SUBJECT: VOGTLE ELECTRIC GENERATING PLANT, UNITS 1 AND 2 - STAFF
ASSESSMENT OF INFORMATION PROVIDED PURSUANT TO TITLE
10 OF THE *CODE OF FEDERAL REGULATIONS* PART 50, SECTION
50.54(f), SEISMIC HAZARD REEVALUATIONS RELATING TO
RECOMMENDATION 2.1 OF THE NEAR-TERM TASK FORCE REVIEW
OF INSIGHTS FROM THE FUKUSHIMA DAI-ICHI ACCIDENT
(TAC NOS. MF3770 AND MF3771)

STAFF ASSESSMENT BY THE OFFICE OF NUCLEAR REACTOR REGULATION

RELATED TO SEISMIC HAZARD AND SCREENING REPORT

VOGTLE ELECTRIC GENERATING PLANT, UNIT NOS. 1 AND 2

Figure 3.3-1 Plot Comparing the Staff's and the License's Median Amplification Functions and Uncertainties for two input loading levels for Vogtle Units 1 and 2

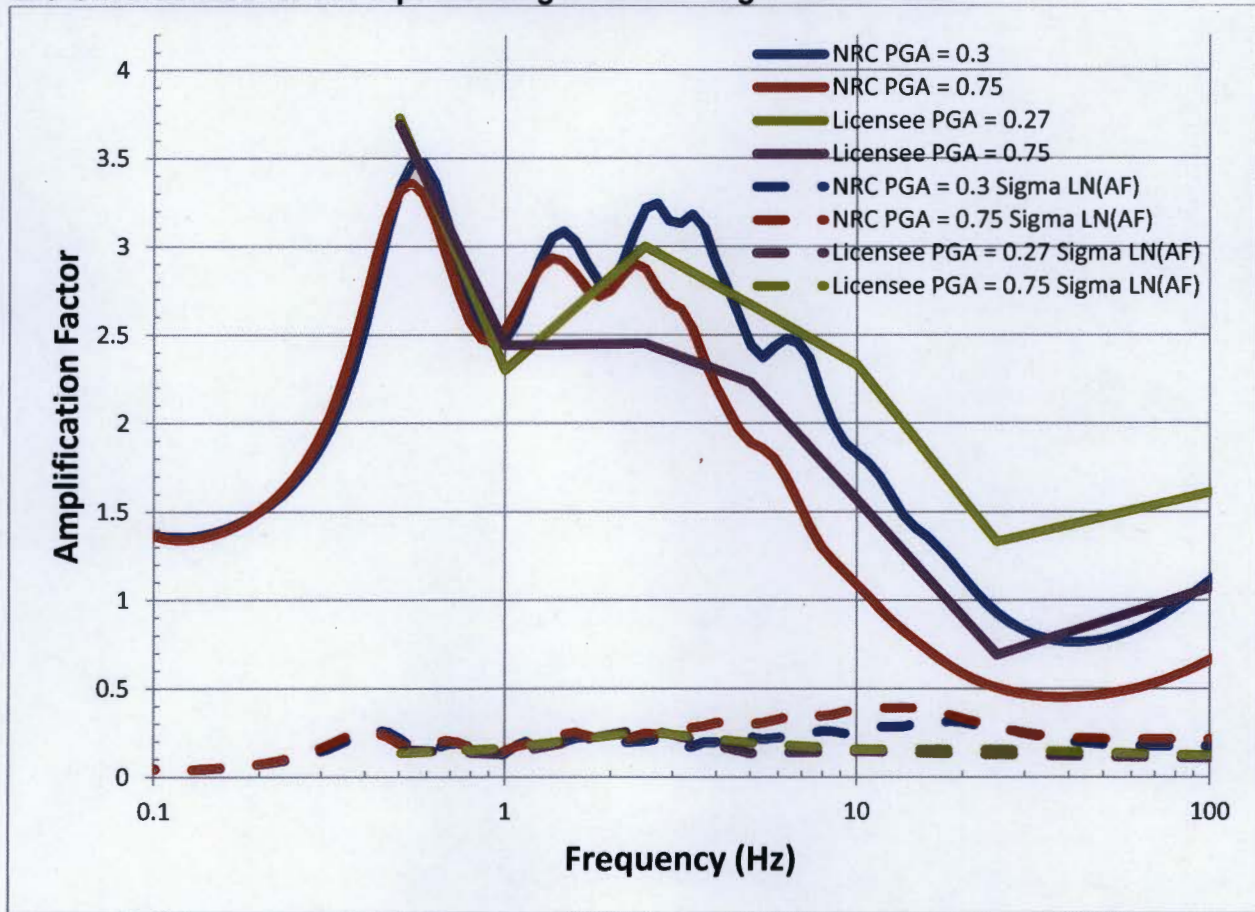
Figure 3.3-2 shows a comparison of the staff's and licensee's median site amplification functions and uncertainties (± 1 standard deviation) for two of the input loading levels. The licensee's approach to modeling the subsurface rock properties and their uncertainty results in amplification factors similar to those developed by the staff. As shown in Figure 3.3-3, these small differences in the site response analysis do not have a large impact on the control point seismic hazard

Figure 3.4-1 Comparison of the Staff's GMRS with Licensee's GMRS and the SSE for Vogtle Units 1 and 2

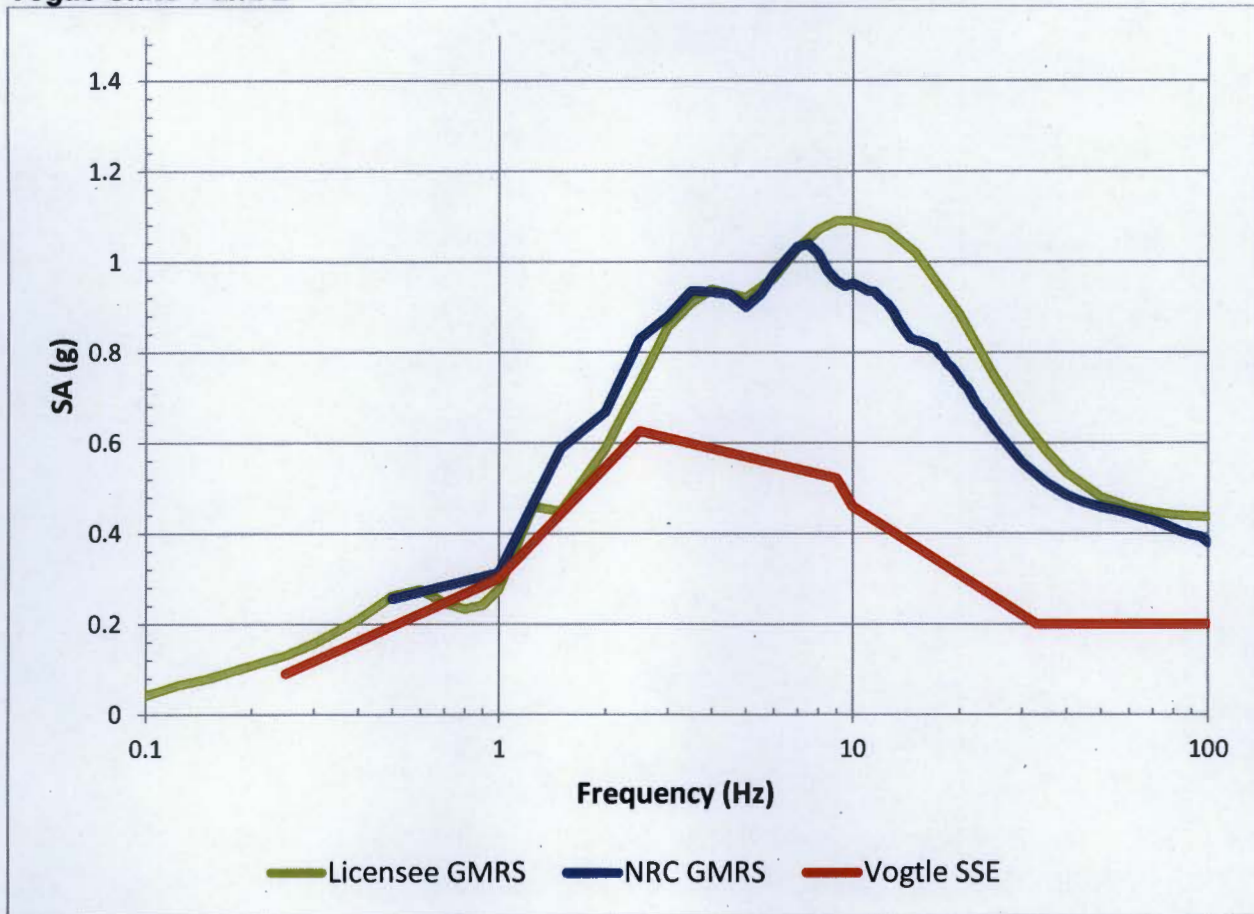
The staff independently calculated the 10^{-4} and 10^{-5} UHRs using the results of its confirmatory PSHA and site response analyses, as described in Sections 3.2 and 3.3 of this staff assessment, respectively. As shown in Figure 3.4-1 below, the licensee's GMRS shape is generally similar to that calculated by the staff.
